<b>BRIEF DESCRIPTION OF REQUEST</b>
Amend approved Site Plan for Subdivision to develop the approved building pad site into a Starbucks.

**RE: PROJECT - 4201 CENTRAL AVE. NW – ALBUQUERQUE, NM. 87105 (ATRISCO PLAZA SHOPPING CENTER)  
LEGALLY DESCRIBED AS: TRACT A A DIVISION OF LAND OF RANCHO VILLAGE PARTNERS CONT 13.1683 AC  
ADMINISTRATIVE AMENDMENT TO SITE DEVELOPMENT PLAN FOR A STARBUCKS PAD**

#### Transportation Development Comments:

DATE: **16 FEB 2021**  
SCALE: **AS NOTED**  
SHEET: **AS102**

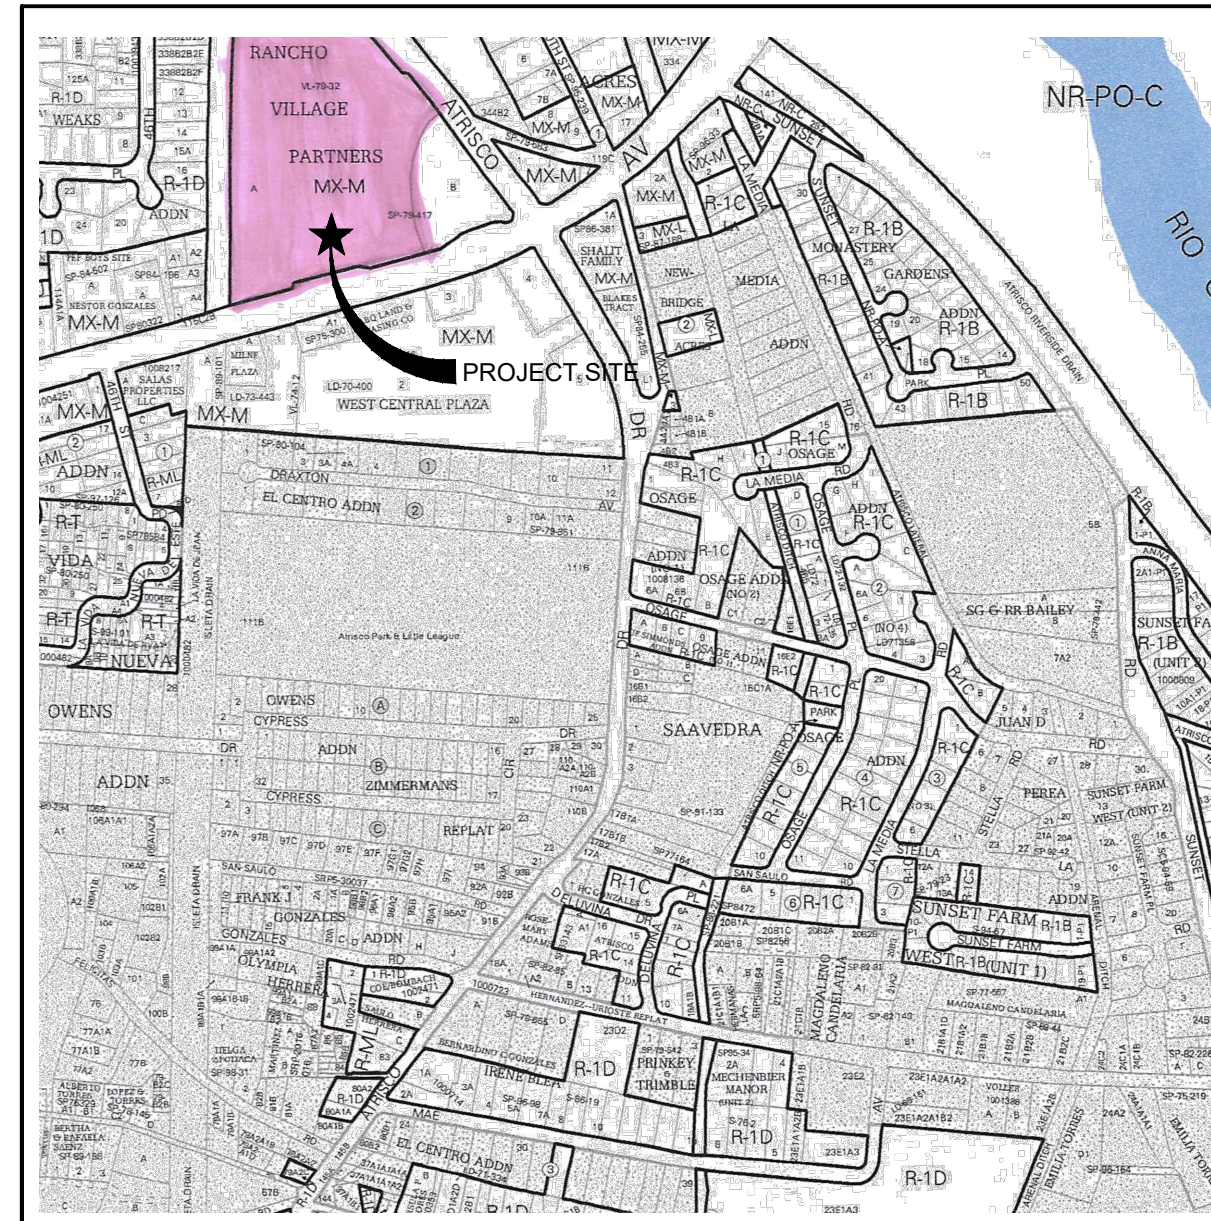
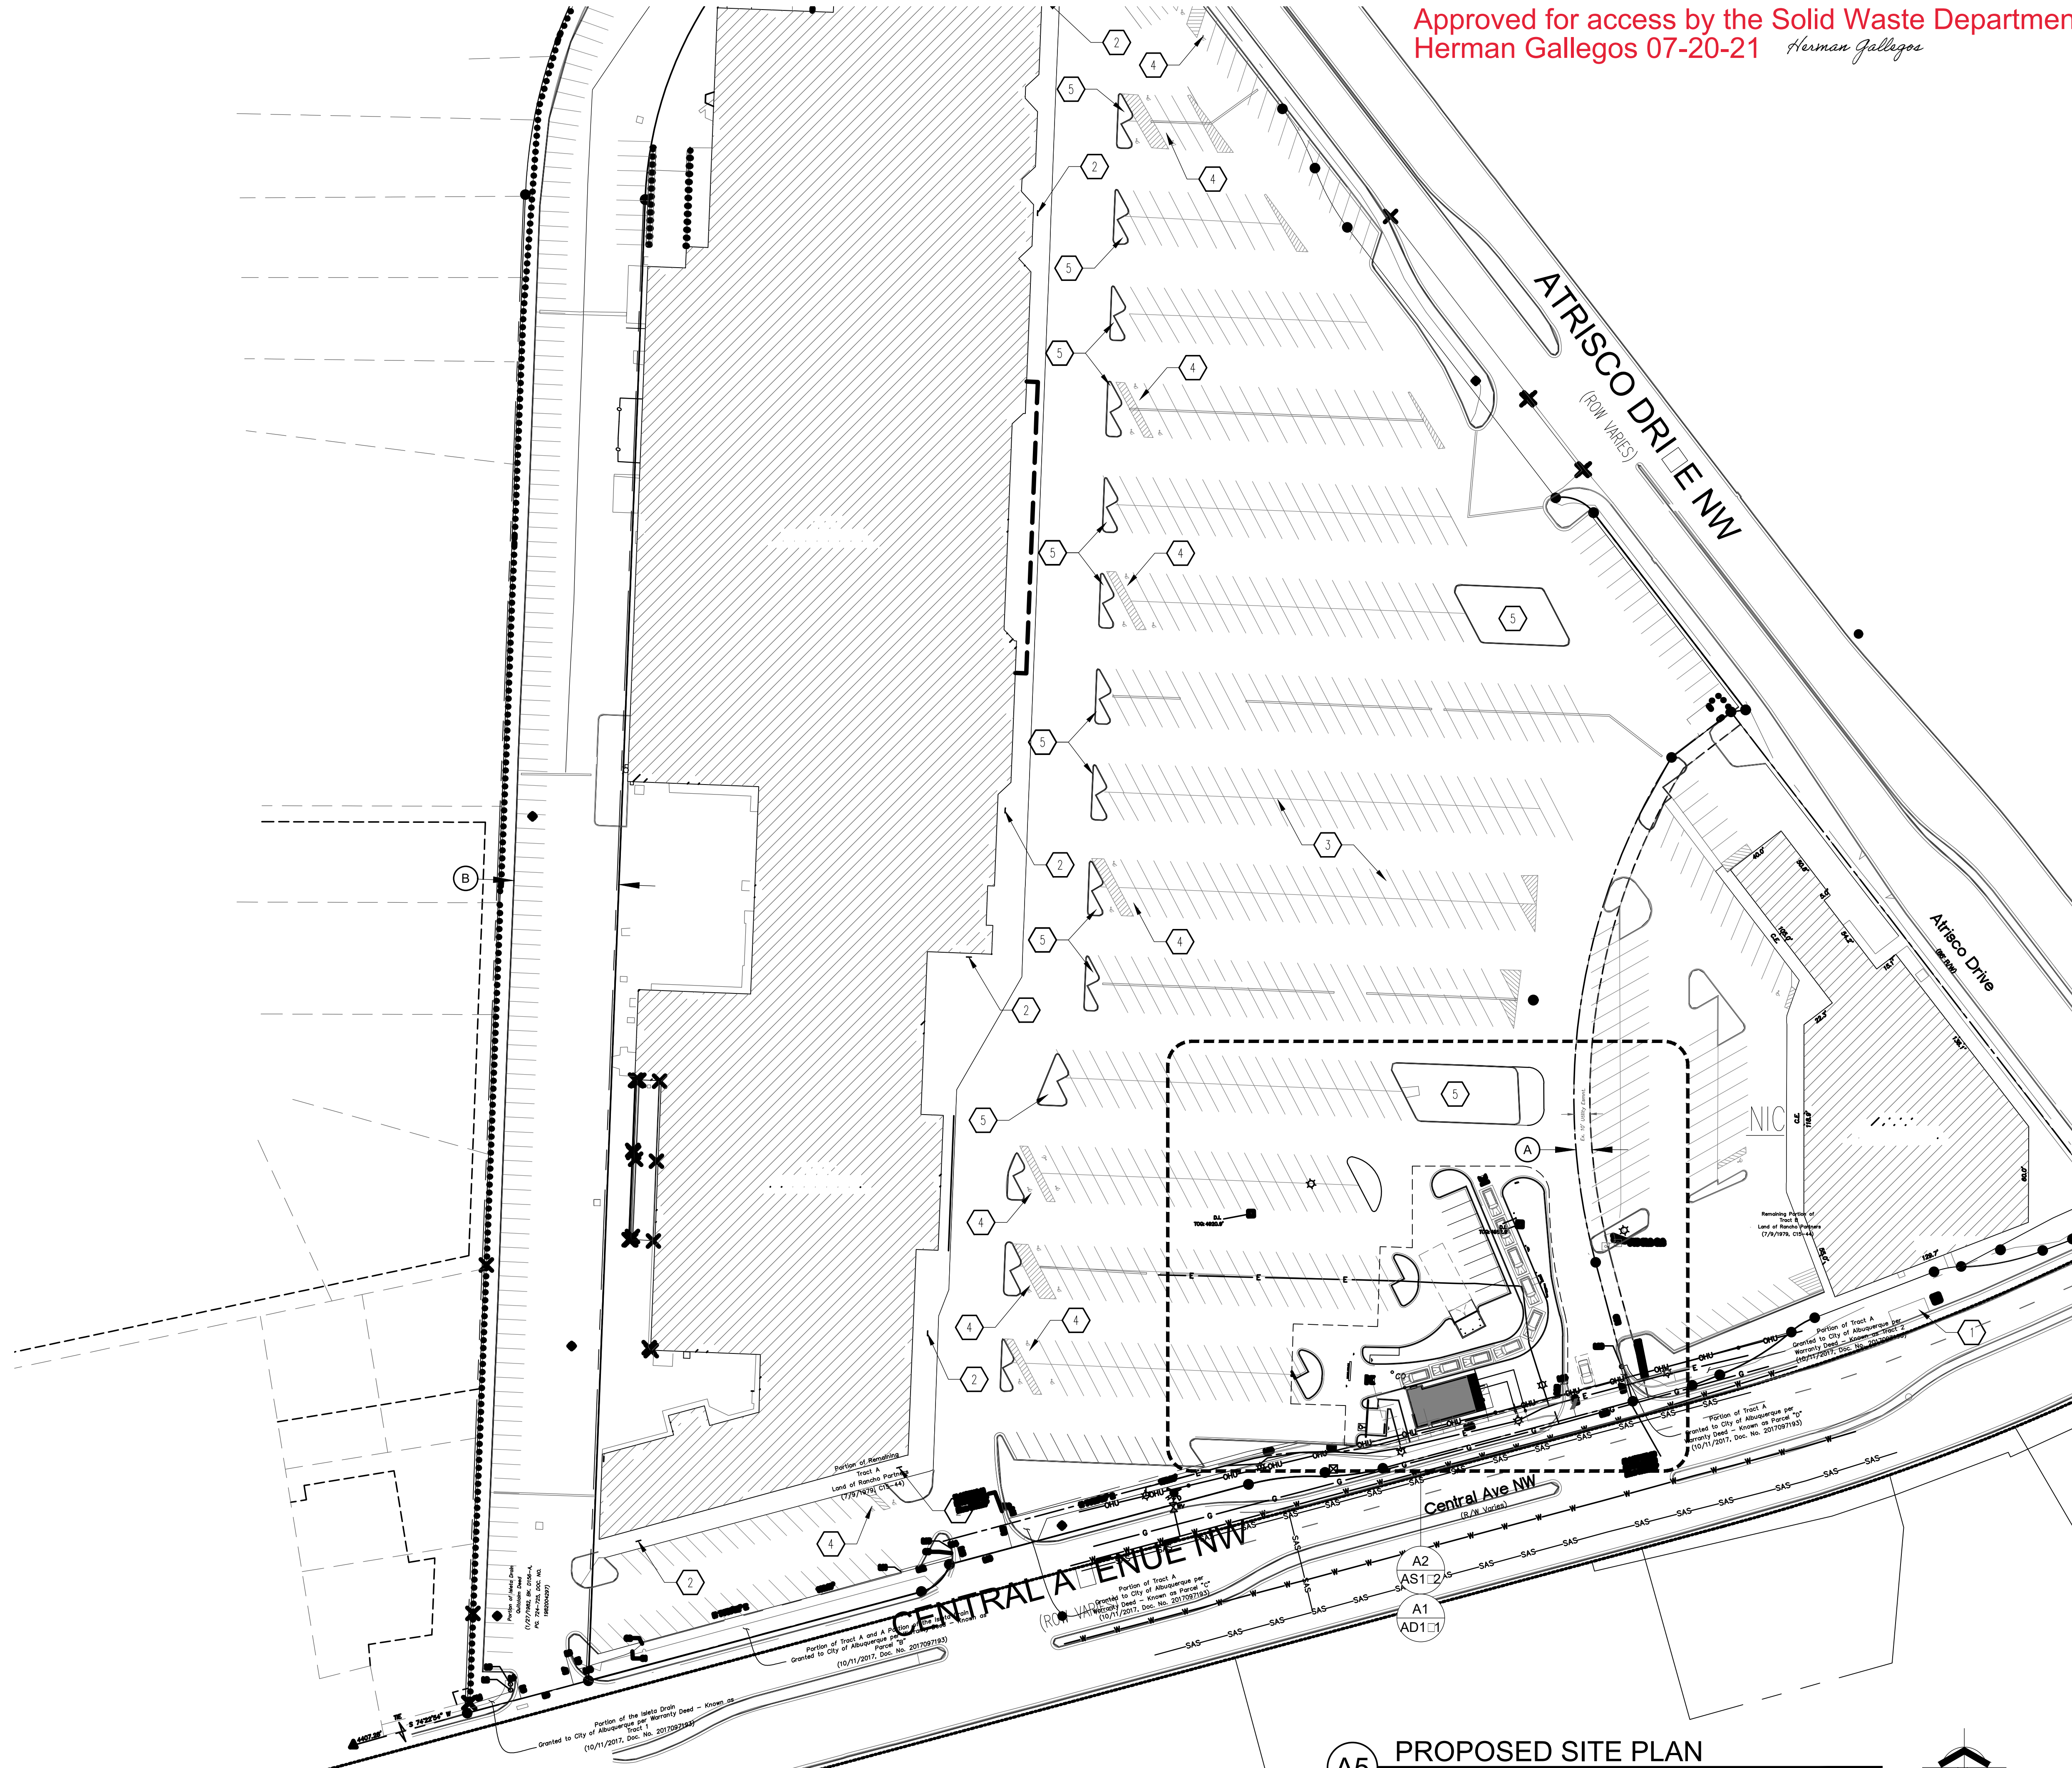
- Provide Solid Waste approval for this site. **Attached is the Solid Waste Approval.**
- Show clear sight triangles at the driveway exit on both the site plan and landscaping plan.

**See added clear sight triangles at driveway entrance/exit on both sheet AS102 and LS101 Landscape Plan.**
- Clarify new features versus existing by use of different line weights in combination with identification in the legend. **Please see updated site plan on sheet AS102.**

- Show all dimensioning of parking spaces. Include length and width of parking spaces and angles, even if existing. **Please see updated site plan on sheet AS102.**

- Include pavement arrows for one-way aisles. Delete Chevron sign graphic shown on pavement. **Please see updated site plan on sheet AS102.**
- Provide 6-foot ADA pathway from the building to the ADA parking spaces. **Please see updated site plan on sheet AS102.**

- The required number of ADA stalls just for the Starbucks should be provided nearby the building for close access. **Please see updated site plan on sheet AS102.**

- Show where the motorcycle parking and bike rack are located. **Please see updated site plan on sheet AS102.**
- For all curb ramp details, indicate 6' minimum for length of ramp to ensure it meets maximum slope requirements. **Please see keyed note #41 on sheet A1.1.**

- Identify all signage locations on the site plans such as handicapped signs, etc. Please see updated site plan on sheet AS102.
